## Recall Inspection and Repair Instructions

**NHTSA Recall # 24V-049**

**Tiffin Motorhomes Recall # TIF-136**

**Purpose:** To provide instructions on how to replace the aluminum solar panel brackets with stainless steel brackets.

Figure 1A, recalled aluminum bracket.

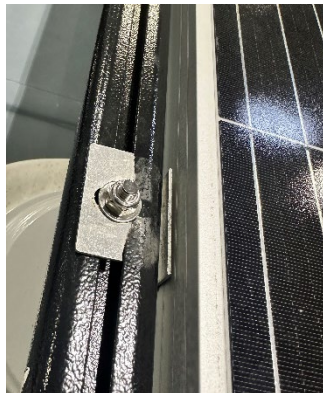
1. Verify which brackets are installed on the motorhome. If they are the updated brackets made from stainless steel, please verify the hardware used to secure the solar panel is correct, if the washers or bolts are incorrectly sized, please update the hardware as needed. See figures 1A, 1B, 1C & 1D below.

Figure 1B, recalled aluminum bracket with stress fractures & incorrect washer.

Figure 1C, updated stainless steel bracket, washer too large for nut.

Figure 5A

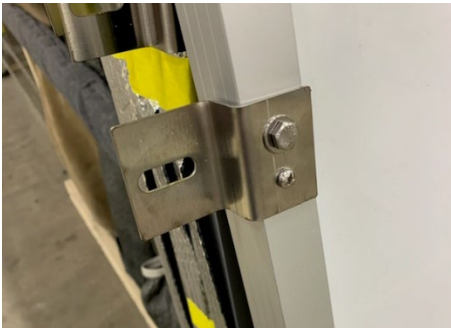
4. Remove the (4) ½” locking nuts holding the solar panel to the roof rack. Remove the panel and transport to a more convenient workspace if preferred.
5. Remove the (4) aluminum solar panel brackets using (2) 7/16” wrenches and a Phillips head screwdriver. See Figure 5A below.

6. Install new stainless steel solar panel brackets to the solar panel. Reattach the solar panel into the same location on the roof rack where the previous brackets were mounted. See Figure 6A
